REQUEST FOR ADDITIONAL INFORMATION

MARK I CONTAINMENT LONG TERM PROGRAM

PLANT UNIQUE ANALYSIS REPORT

BRUNSWICK STEAM ELECTRIC PLANT

CAROLINA POWER & LIGHT COMPANY BRUNSWICK STEAM ELECTRIC PLANT				
STRESS ANALYSIS DIAGRAM NUCLEAR STEAM SUPPLY SYSTEM 24' PRIMARY STEAM LINE 'A' & 10' HPCI STEAM SUPPLY UNIT NO. 3 SHEET NO. 514				
E.I. Engineering

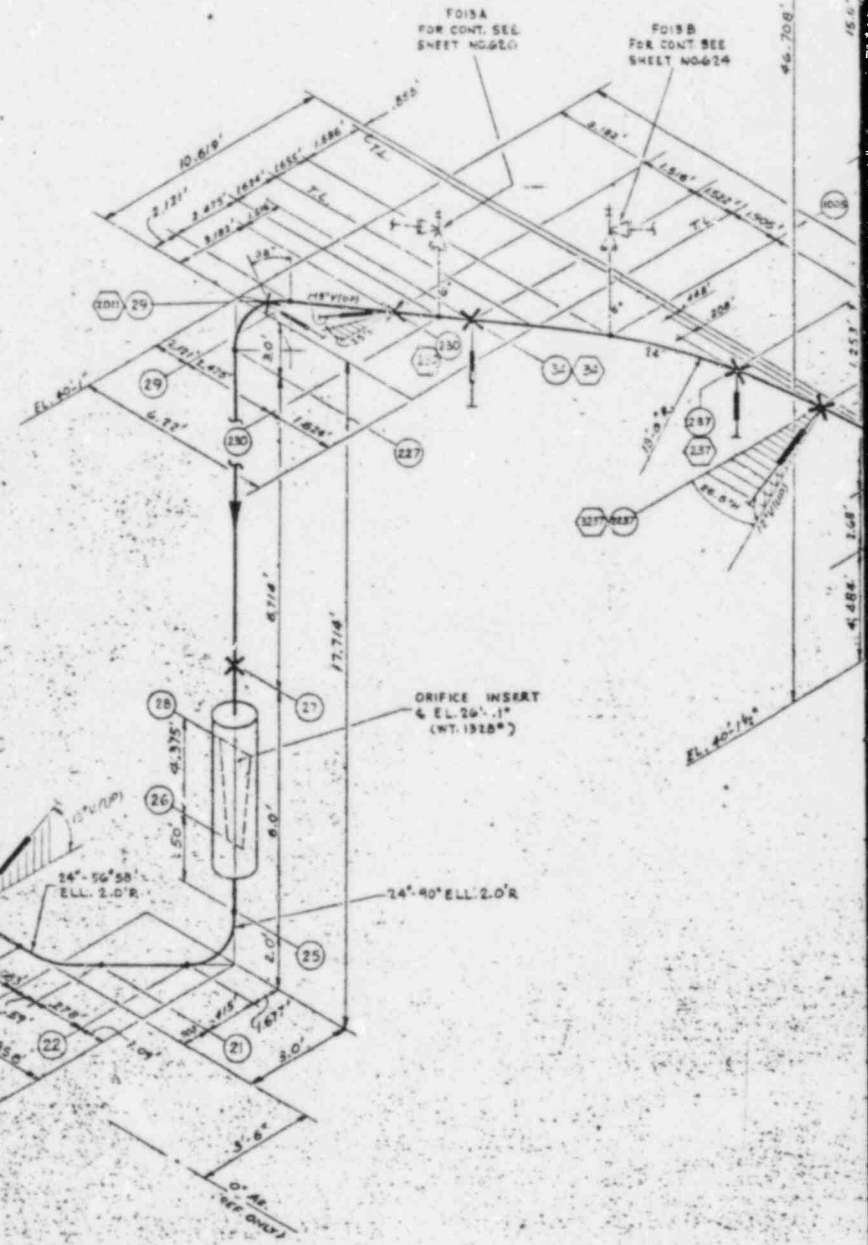
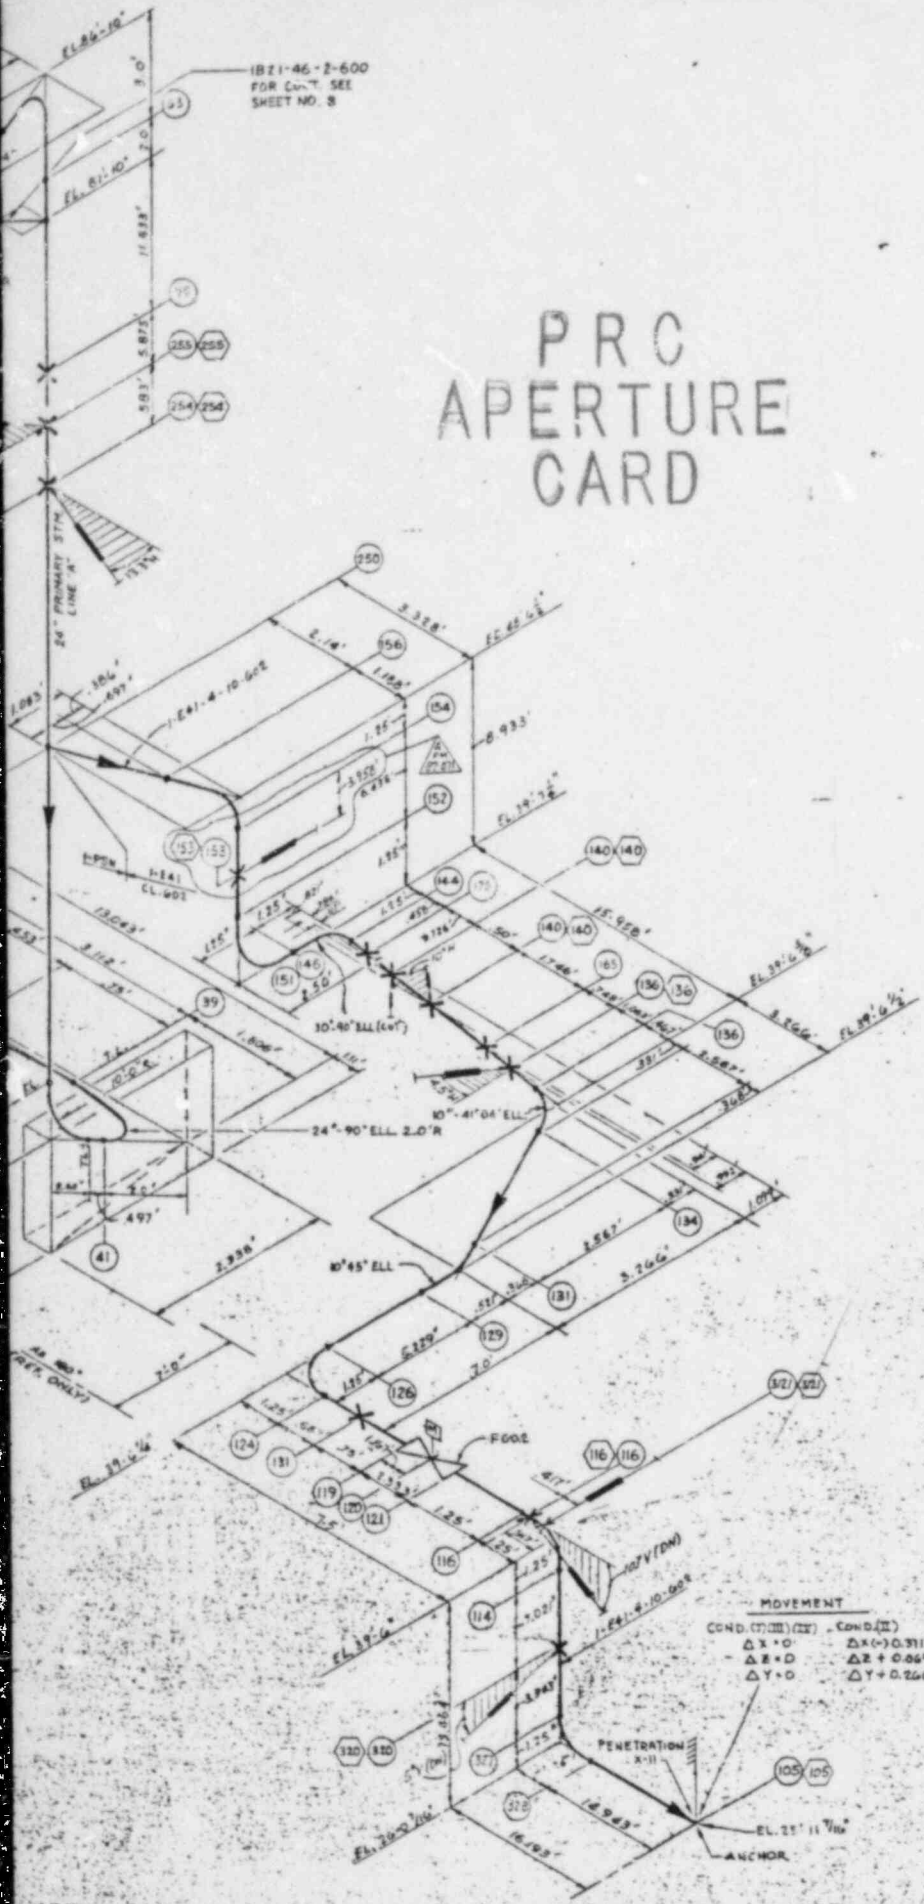
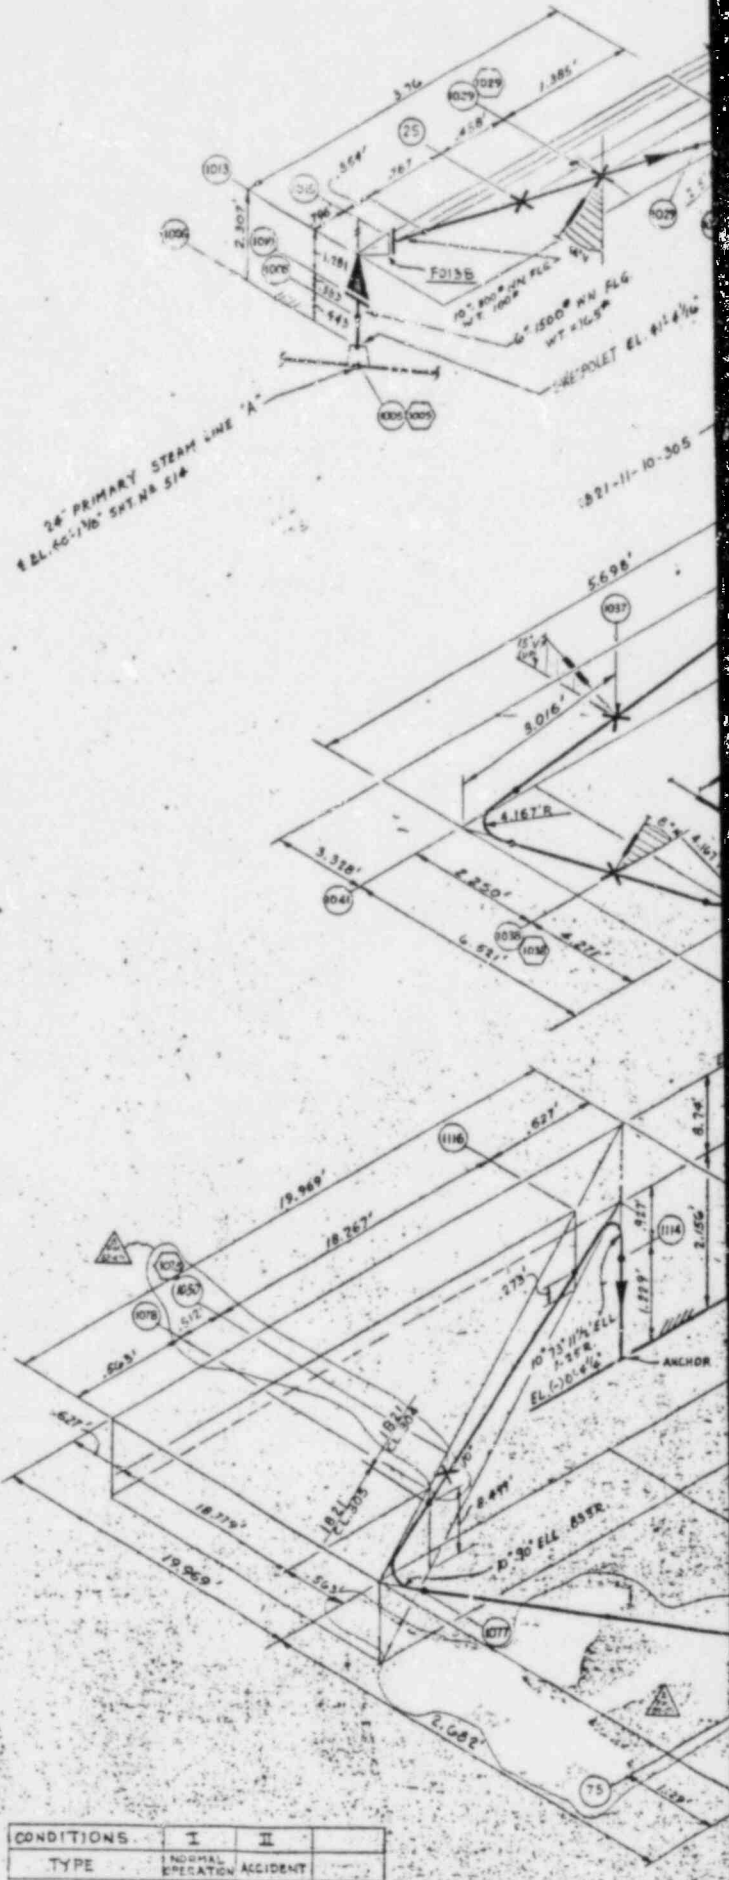
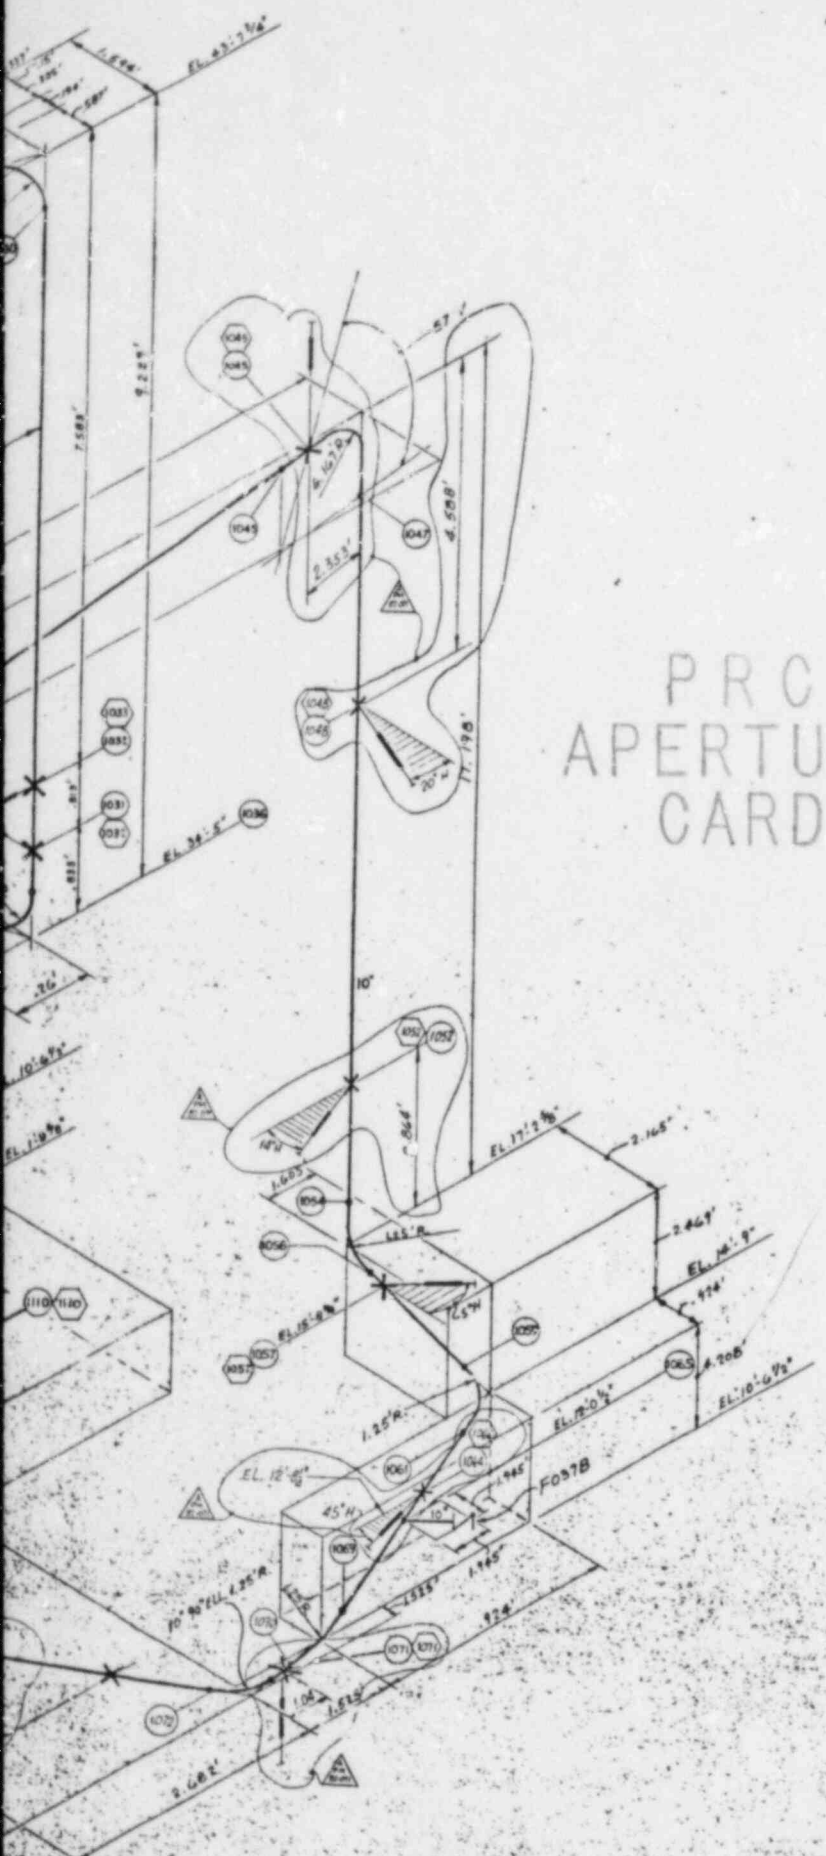
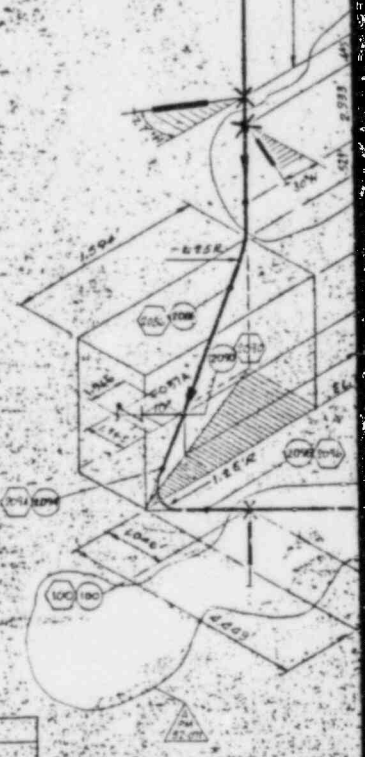
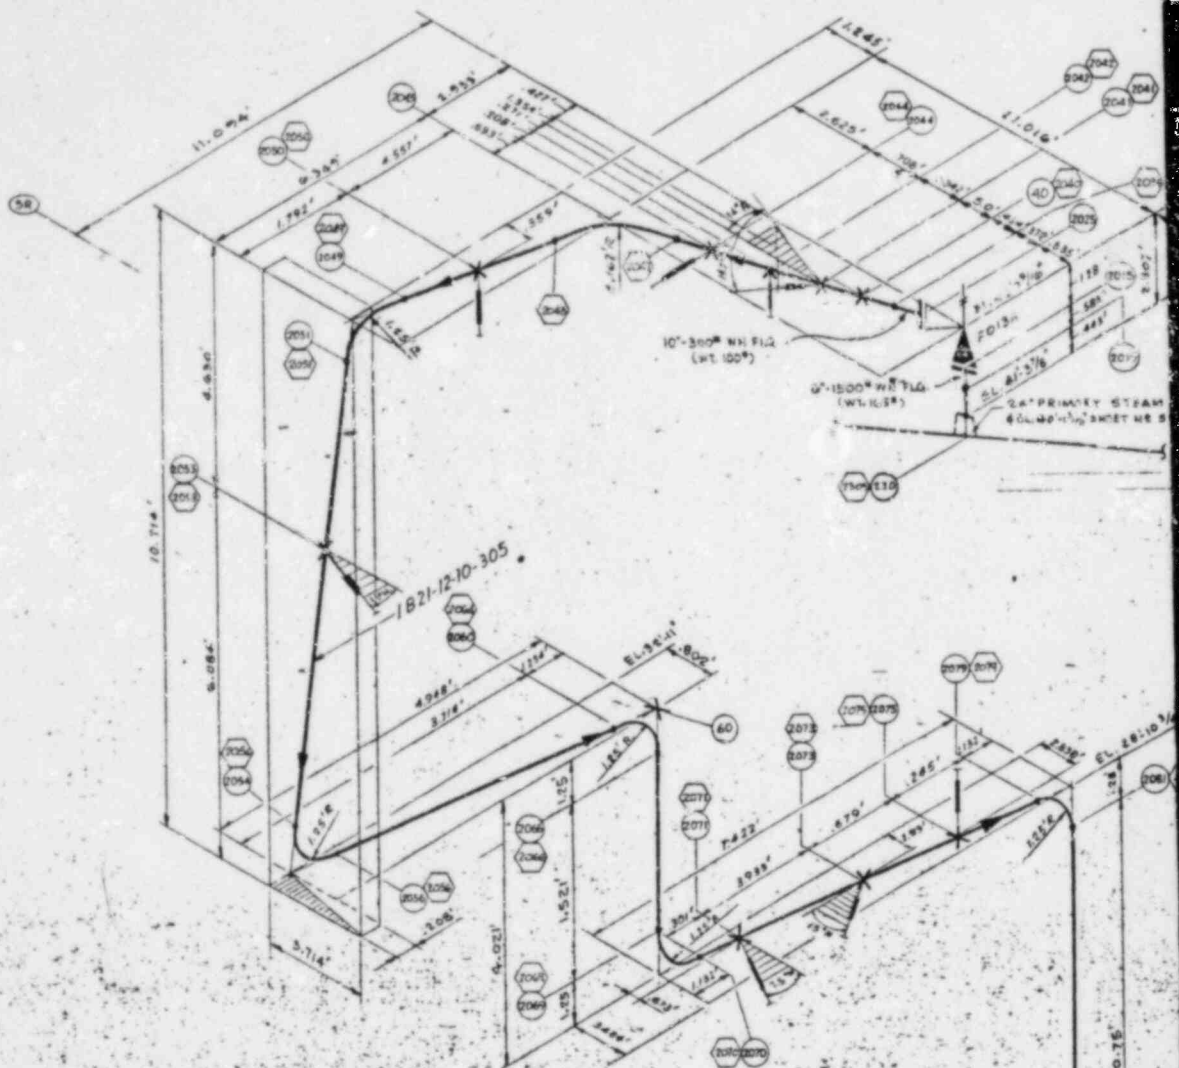
RAI 3a Provide a summary of the analysis for each safety relief valve (SRV) discharge piping which should include the analytical model with piping and supports, from nozzle at main steam line to discharge in suppression pool, discharge device, and its supports.

The safety relief valve (SRV) discharge piping analysis is divided into two models. The upper model includes the primary steam line with the attached SRV discharge piping lines in the drywell down to the vent header. The lower model includes the SRV discharge piping from the vent header downstream into the suppression pool and is discussed in detail in the Plant Unique Analysis Report section 2.3.11.

The upper model of SRV discharge piping including primary steam line was analyzed for the usual thermal, dead weight, and seismic loading conditions as well as SRV discharge transients. The piping model with supports is shown on the attached isometric drawing, sheets 514, 624 and 626.

FIGURE 2-1. METHOD OF TIME PHASED RESPONSE COMBINATION

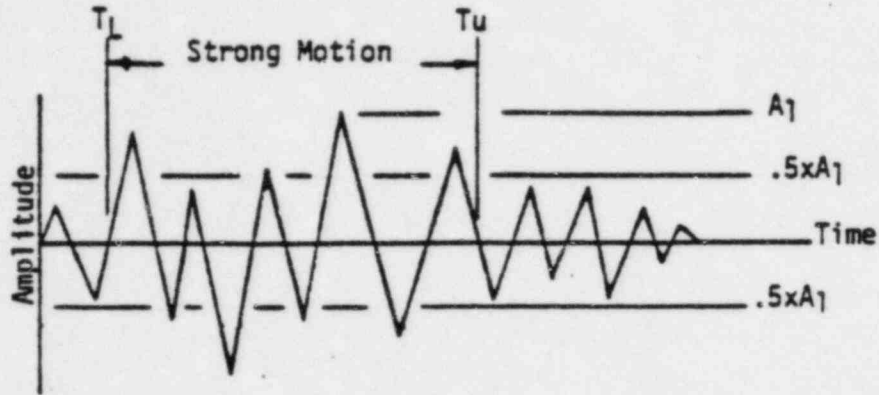
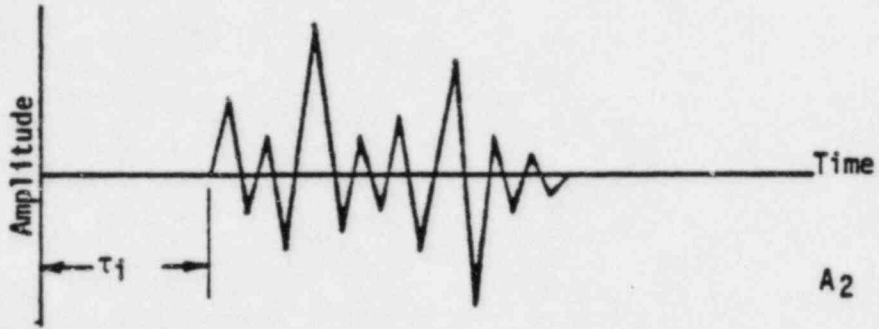
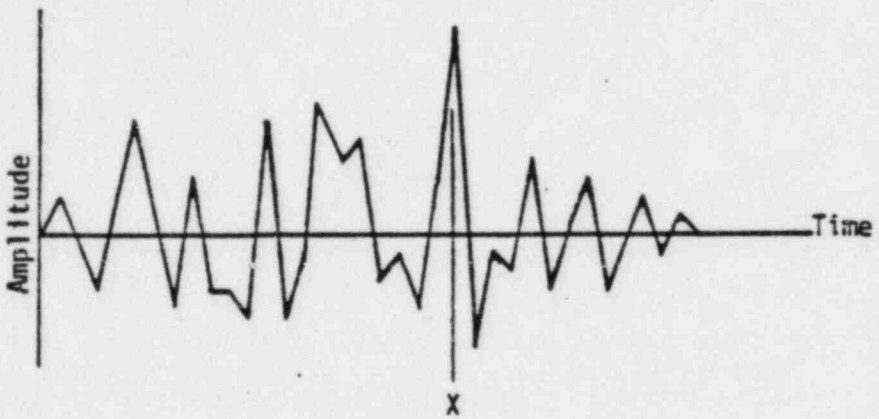
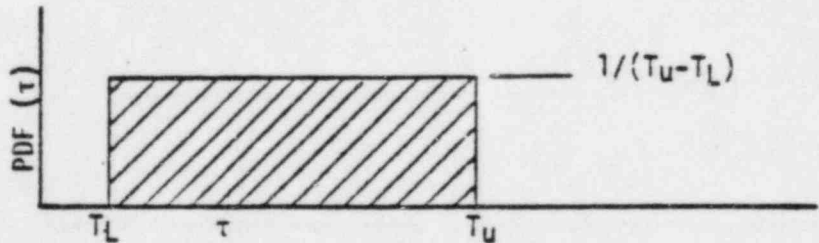
RAI 15 With reference to Section 3.8.4.2 of the PUA report (4), provide justification for using the SRSS method for combining responses due to SRV and chugging loads, specifically indicating whether the stress intensity value corresponds to 84% probability of non-exceedance as determined from the cumulative distribution function.

Justification for using the SRSS method to combine responses due to SRV and chugging loads is provided in "SRSS Response Combination of Multiple Dynamic Responses" by R. P. Kennedy, Structural Mechanics Association, dated August 1982 (September 9, 1982 NRC Presentatioin Document).

FIGURE ITEM 25-A

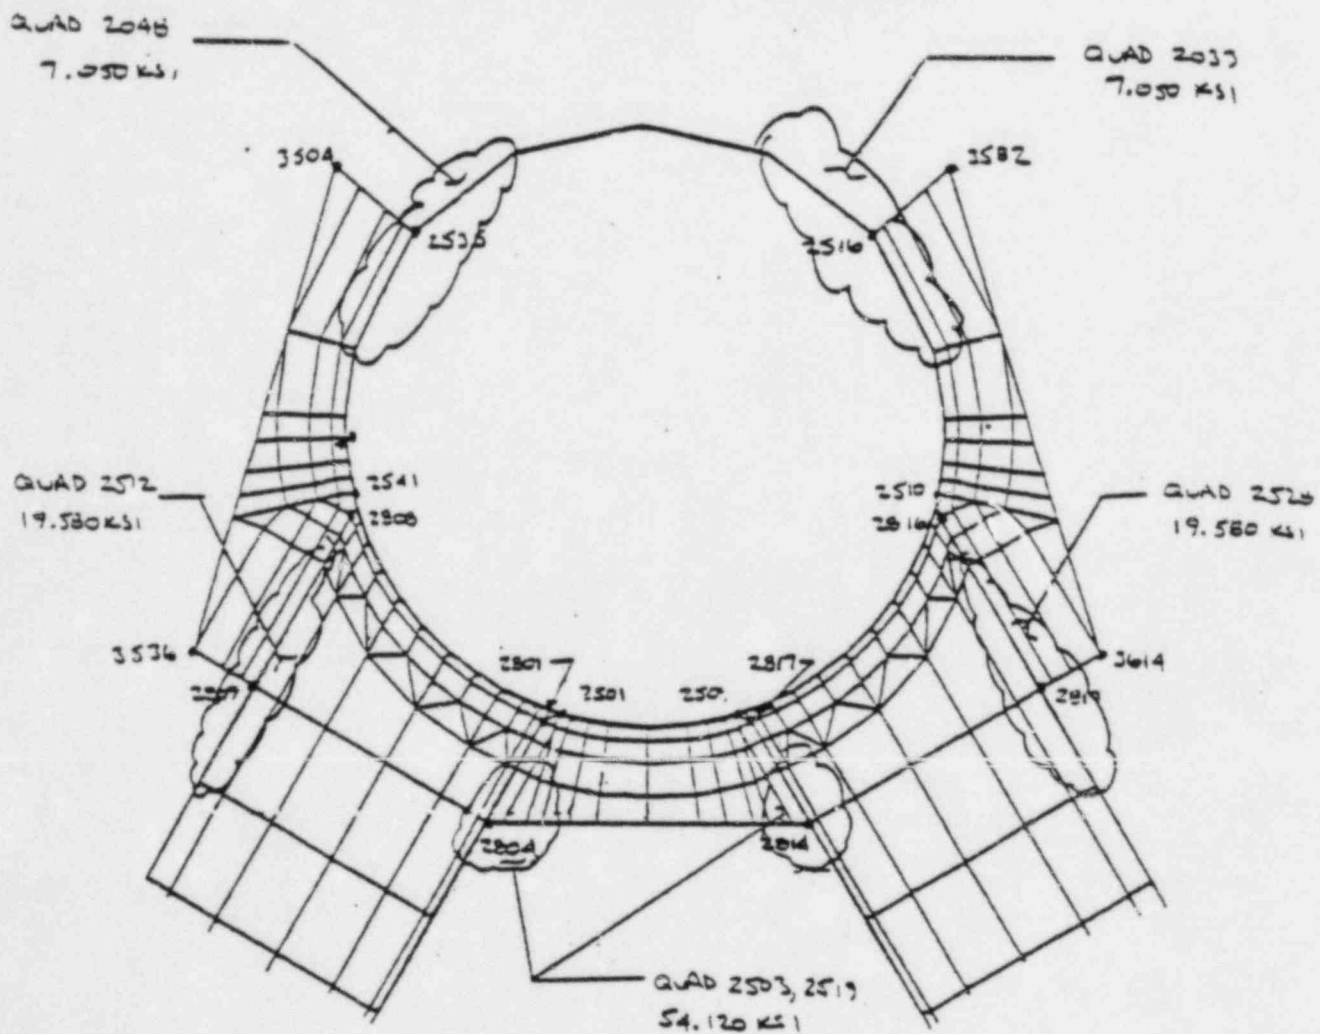
RAI 25a The downcomer/vent header finite element model shown on Figure 3.6.1.1-12 (4) indicates that large elements with non-conventional aspect ratio were used at some regions of discontinuities, such as the stiffening plate regions attached to the downcomer and to the vent header. Indicate the calculated stress intensity values at such locations.

The calculated maximum stress intensity values at element locations in the regions of discontinuity are shown on Figure Item 25-A, Attachment RAI 25b-1. Locations corresponding to high stress intensity values given in Table 3.8.4.3.1 are marked on Figure 3.6.1.1-12, Attachment RAI 25b-2 and Figure 3.6.1.1-13, Attachment RAI 25-2, (attached).
